Product Change Notification

PCN-CM017

Subject: Change to Carrier Tape of XLamp® XP Family LEDs

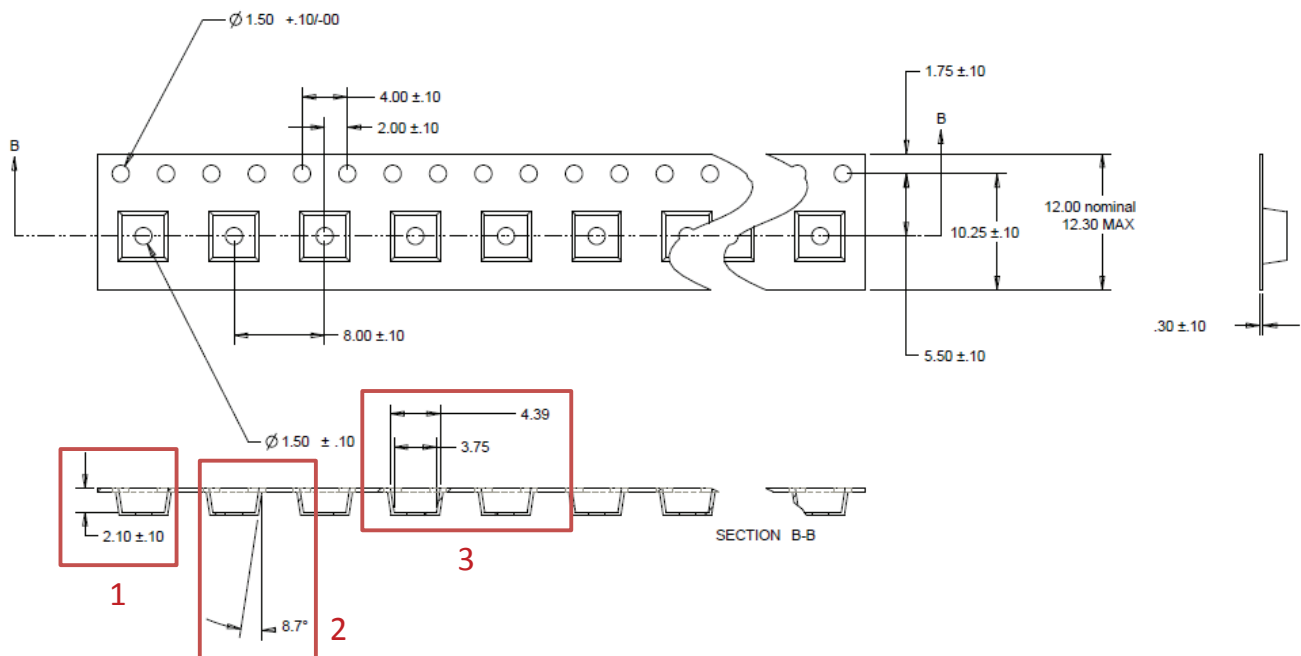
Cree began production of XLamp XP Family LEDs using a new carrier tape on June 10, 2011. This new carrier tape provides improvements in the presentation of the LED within the carrier tape in order to minimize shifted or tilted LEDs. The placement of the LEDs within the tape has not changed. The new drawing as well as the changes are described in the diagram below.

Change	Old Value	New Value	Reason for Change
1. Overall tape height change	2.5 ±0.1 mm	2.1 ±0.1 mm	Prevent LED tilt within pocket
2. Change in sidewall design	Stepped sidewall	Straight sidewall at 8.7°	Prevent LED tilt within pocket
3. Smaller pocket bottom	3.85 ±0.1 mm square	3.75 ±0.1 mm square	Minimize LED shift within pocket
